City of Richmond
Planning and Development Department

Report to Committee

To: Planning Committee **Date:** February 25, 2008
From: Brian J. Jackson, MCIP **File:** RZ 07-361266
Director of Development
Re: **Application by Orion Estates Ltd. for Rezoning at 7140 Railway Avenue from Single-Family Housing District, Subdivision Area E (R1/E) to Comprehensive Development District (CD/54)**

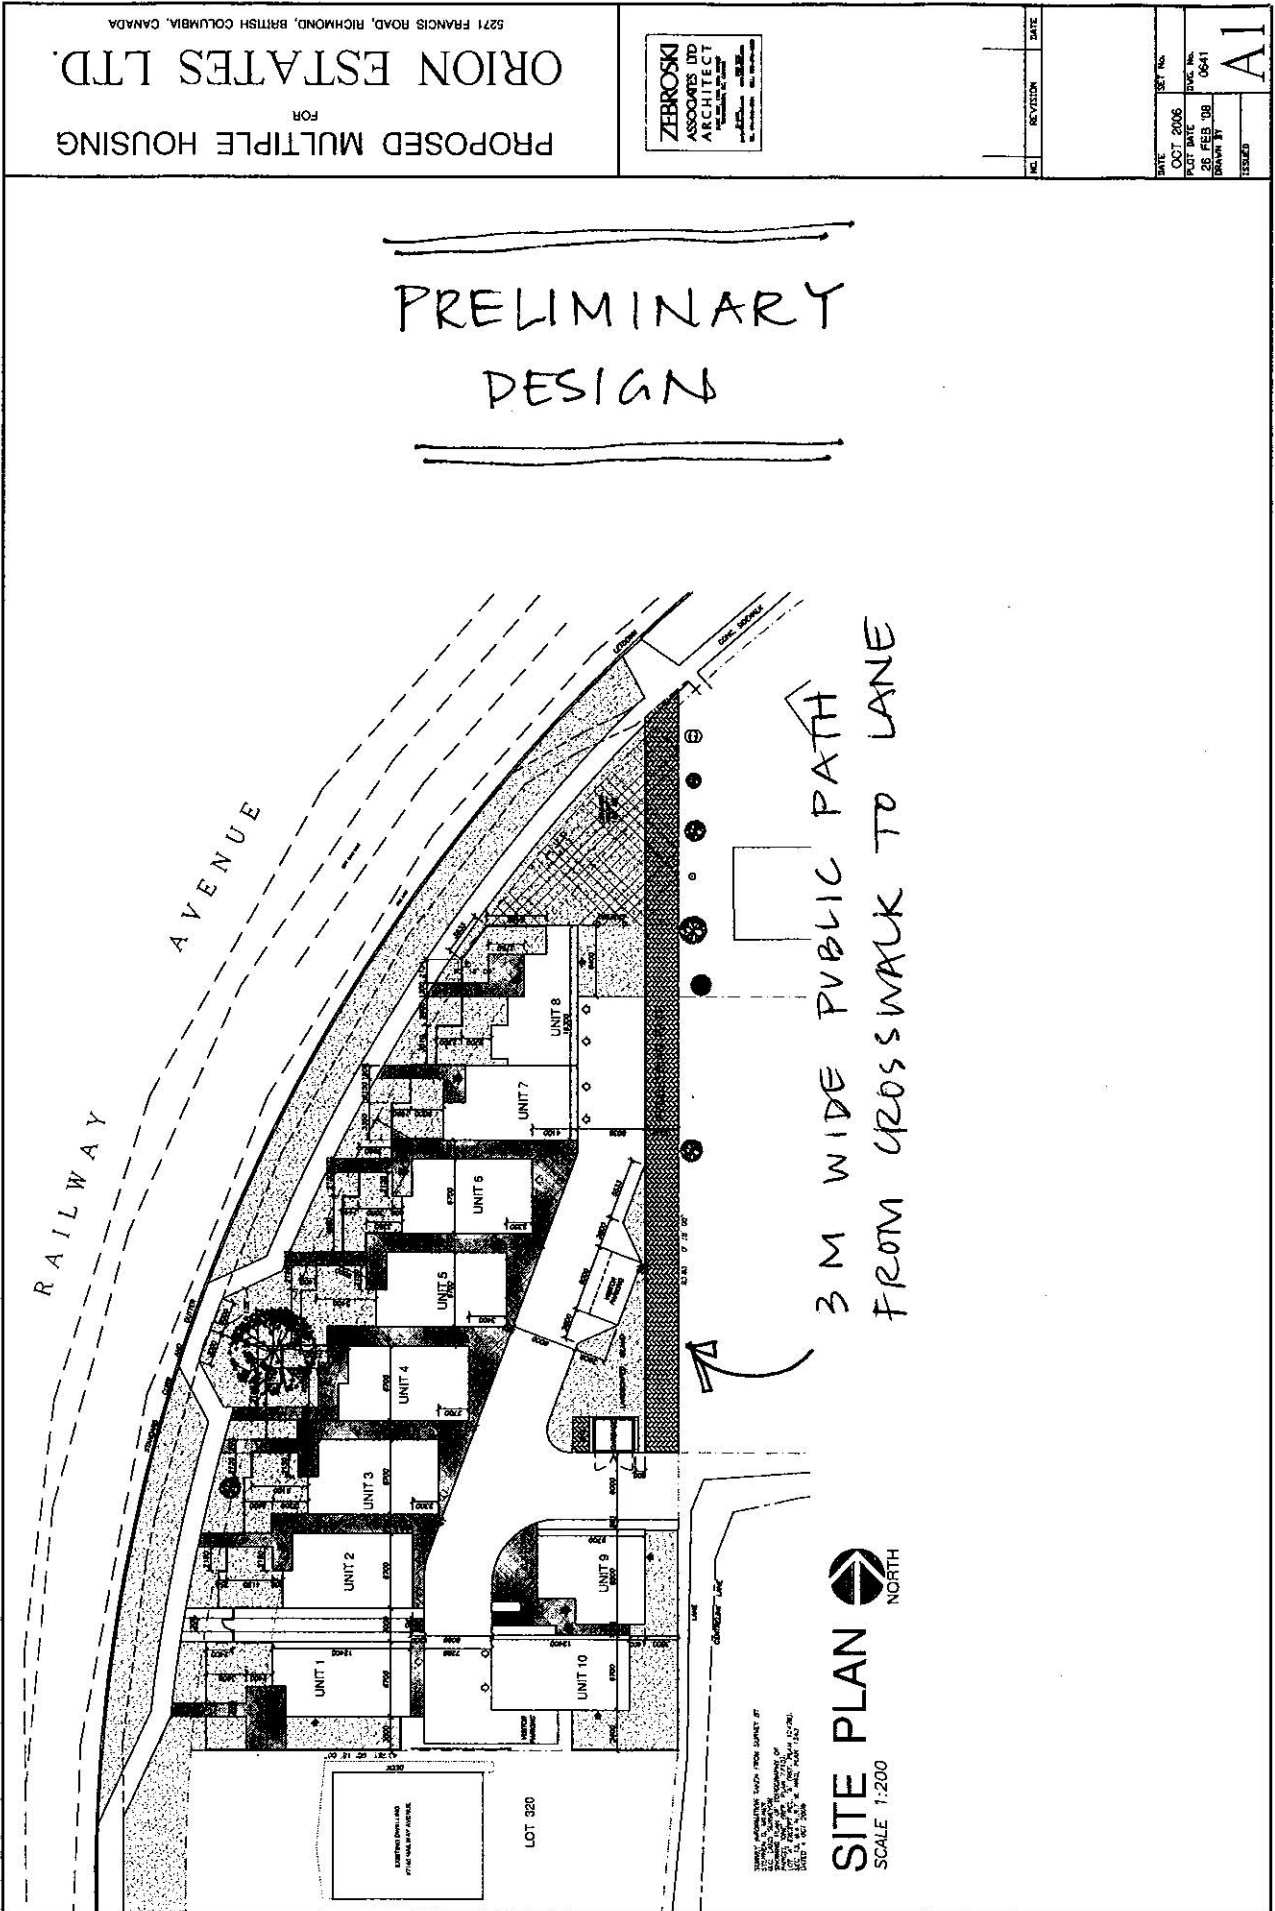
The applicant has developed a preliminary design for this site (**Attachment 4**). The following items will be further investigated at the Development Permit stage:

- Detailed review of building form and architectural character. Design development is needed throughout the project to provide articulation, harmonize proportions, rationalize garage design, and emphasize pedestrian orientation;

- The number and dimensions of off-street parking stalls, including accessible spaces, to be in accordance with the City Zoning and Development Bylaw, Division 400. Detailed dimensions of parking stalls to be provided on plans;

- Detailed mailbox and garbage/recycling structure design. The mailboxes to be at least 6 m away from the vehicle entry;
- Detailed landscaping design, including an internal on-site outdoor amenity area;

- Careful detailing of the building and front yard area adjacent to the Oak tree which is to be protected and retained in the boulevard. As noted previously, Parks Department staff is concerned about compounded impact of construction activity on the long-term health of the Oak tree. Successful protection will need coordination between the contractor, site arborist, engineering design consultant, City Engineering and Parks staff; and

APPENDIX 3
REVISED TREE PROTECTION PLAN

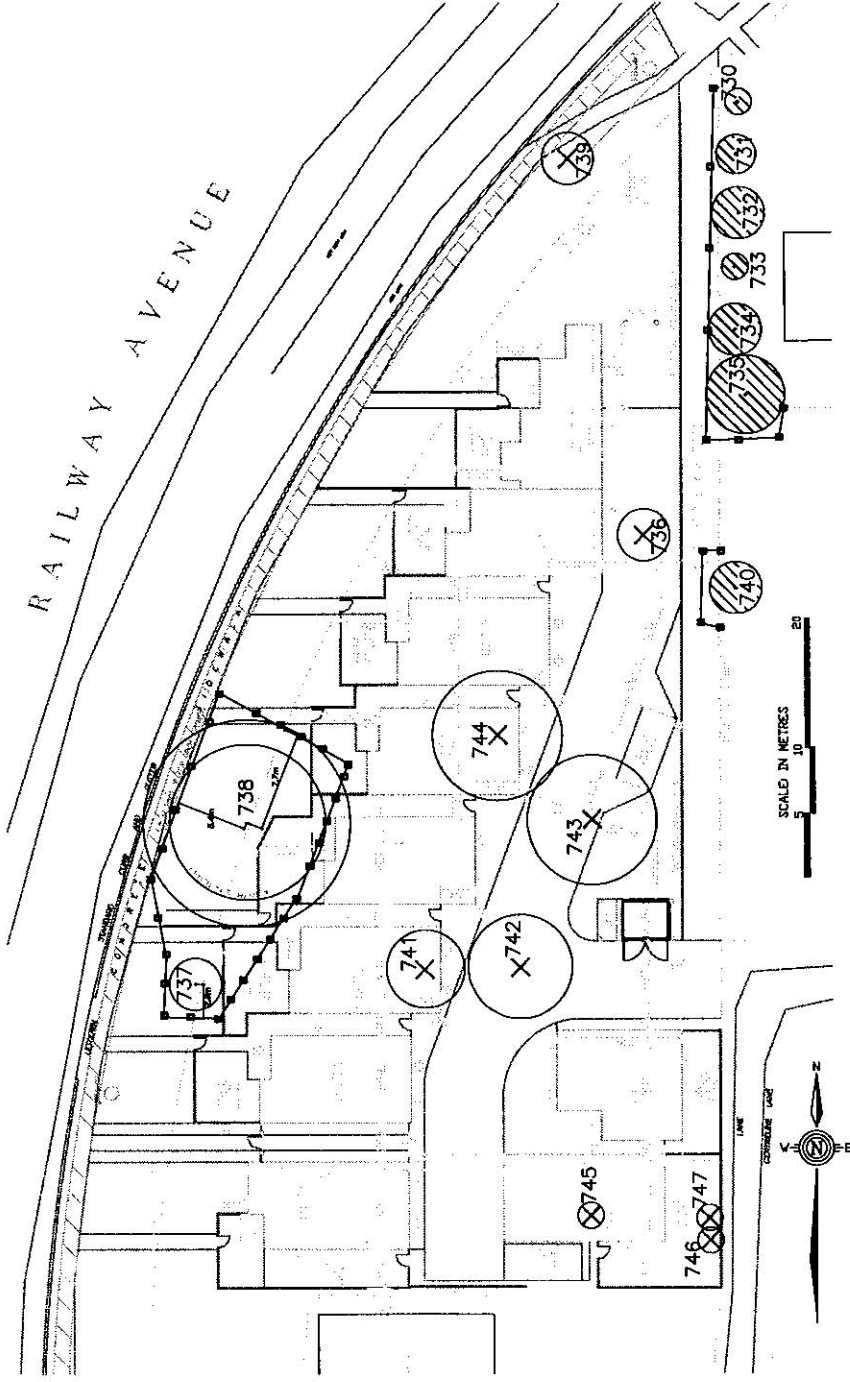
All retained trees on the City Property and neighbouring properties will be surrounded by Tree Protection Fencing as laid out in the **Tree Protection Plan** drawing Appendix 3. All fencing must be constructed to a robust standard and clearly signed: "TREE PROTECTION AREA – KEEP OUT" See Appendix 2 for construction details.

- Protection fencing is to be installed along the edge of the existing sidewalk and can only be removed in the presence of an arborist.
- The excavation must be kept as far to the west as possible along the east edge of the road.
- A Protection Cage should be used for shoring up the excavation to reduce the width of the cut adjacent to the trees. (WCB requirements)
- The contractor for the storm water line and the Arborist must have an on-site meeting to discuss protection measures prior to the work beginning.
- An arborist must be on site during the excavation within the Minimum Trenching Distance of the tree (6 metres from the centre of the tree) to be able to assess the damage and to cleanly cut any damaged roots.
- The drip line of the tree should be mulched after the excavation.
